Access Compliance Report Public Rights-of-Way (Pedestrian Signals)

Main Street: FRONTERA_ST Cross Street: N_GLASSELL_ST Location: SE

ADA ID: SGAT220127091624 Signal Type: One Push Button-Non APS Overall Compliance: No Severity Scores: BTN 1: 35 BTN 2: N/A No BTN: N/A

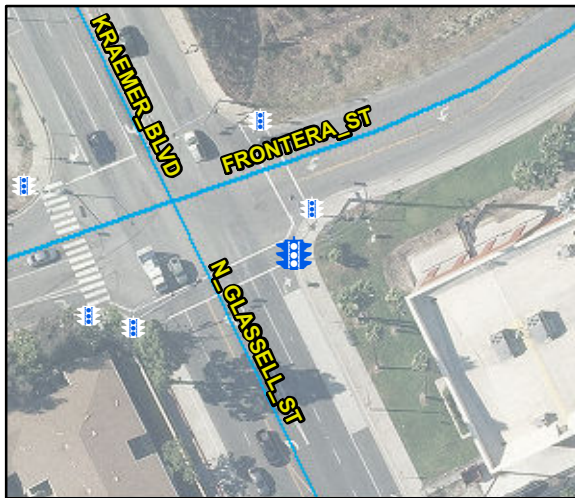
OC Std/PROW: R404.2, R404.3, R403.4, MUTCD 4e.08

Possible Solutions: Replace Signal Push Button With APS Button. Remove and Replace Clear Space.
